Subject: Docket ID NRC-2011-0012; NRC-2015-0003 “Low-Level Radioactive Waste Disposal”

The purpose of this letter is to provide comments to the NRC regarding the proposed revisions to 10CFR61 and 10CFR20 related to low-level radioactive waste (LLRW) disposal as presented for public comment on March 26, 2015. These comments are based on EPRI’s technical research in the area of LLRW and comments previously submitted to the NRC on this topic.

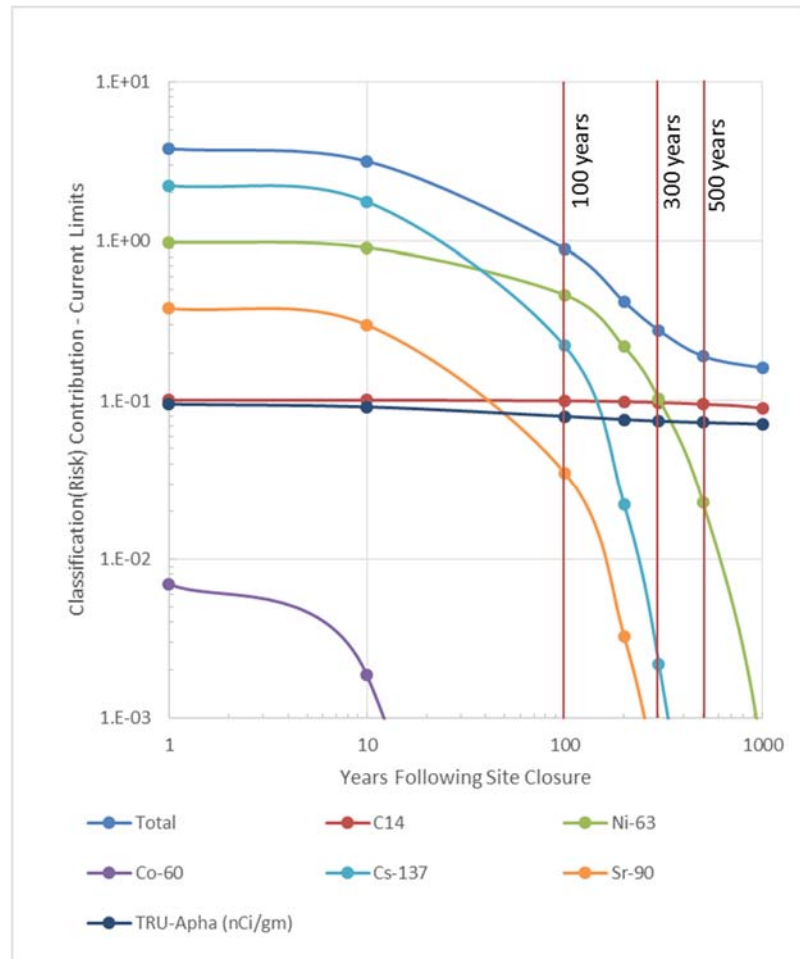
EPRI research indicates that the majority of activity in LLRW from nuclear utilities consists of radioisotopes that will decay to minimal levels within 300 years. This recognition was fundamental to the original framing of 10 CFR 61, which concentrated primarily on non-fuel waste generated from power plant operations (EPRI, 2010). A graph of average concentrations of primary radionuclides from nuclear utilities is shown below.

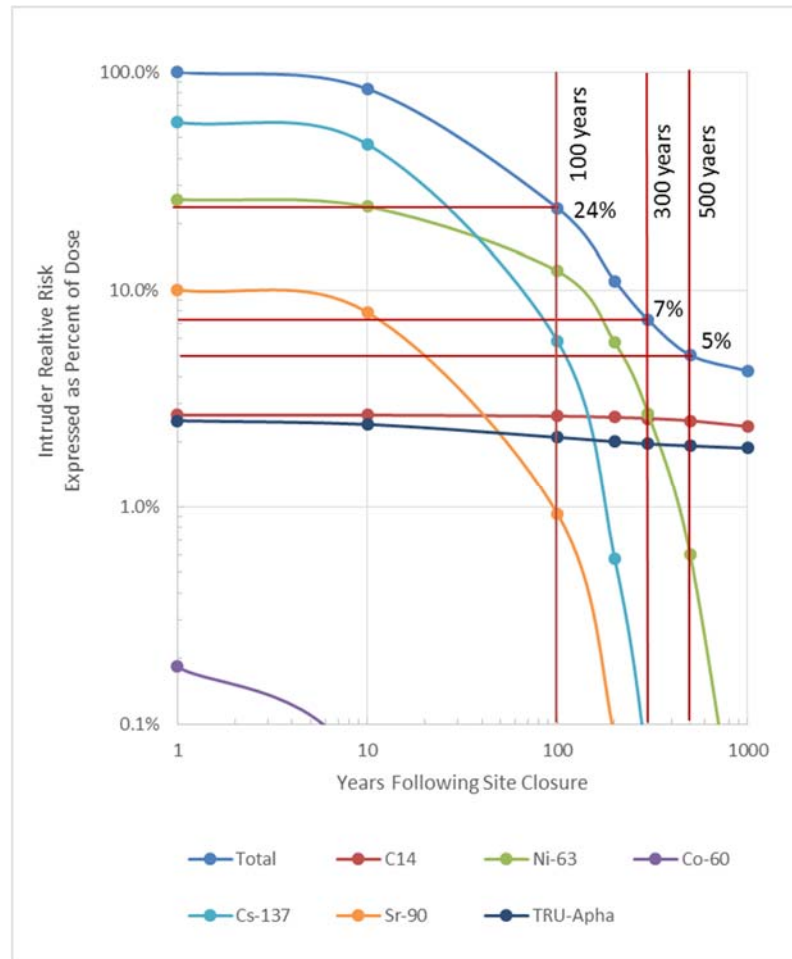
The concentration values identified above can be divided by the existing 10 CFR 61.55 concentration limits as a measure of risk. The results are shown below.

For the first 300 years disposal risk is driven almost entirely by  $^{137}\text{Cs}$  and  $^{63}\text{Ni}$ . After 500 years, only  $^{14}\text{C}$  and TRU continue to stand as dominant risk contributors, but at reduced levels from that observed during the first 300 years. Neither  $^{14}\text{C}$  nor TRU in this mixture are ever more than about 10% of the Class A limits (EPRI, 2010).

This data indicates that the relative total intruder risk at 100 years is 24% of the intruder risk at the time of site closure. However, based on the international studies referenced above, the more probable time for the failure of institutional controls is 300 years after site closure. The relative total intruder risk at 300 years is 7% of the risk at the time of site closure. As such, when 100 years is used as the time period for intrusion (coincident with the loss of active institutional controls), the risk is three times higher compared to when intrusion is more likely to occur. While the proposed rule assumption that inadvertent intrusion occurs immediately after the loss of institutional control is a reasonable and conservative approach, the time of the loss of institutional control should be re-evaluated.
